Update – Critical Product Correction and Product Alert

ACCOLADE™ single chamber (SR), dual chamber (DR) standard life (SL) and DR extended life (EL) pacemakers; and VISIONIST™ cardiac resynchronization therapy pacemakers (CRT-Ps)

TGA Ref: RC-2024-RN-001116-1

March 2026

Figure 1: Follow-up for devices active on LATITUDE NXT Remote Patient Management System

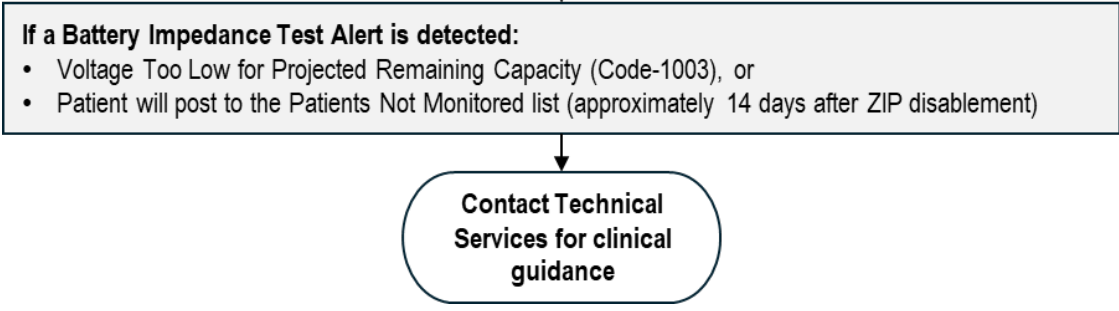
- All other patients: Schedule the next in-person follow up at a frequency described in the IFU: every 12 months or every 3 months if the battery status reaches One-Year-Remaining.
- Once pacemaker software has been upgraded, follow devices using the applicable flow chart below, based on the remote monitoring status (Figure 1 and 2).
- Update the medical record for each patient with an affected device (see Appendix A) by appending this letter to ensure continuous awareness throughout the device’s remaining service life.
- Complete and email your Customer Response Form(s) to ANZ_Incident_Report@bsci.com.
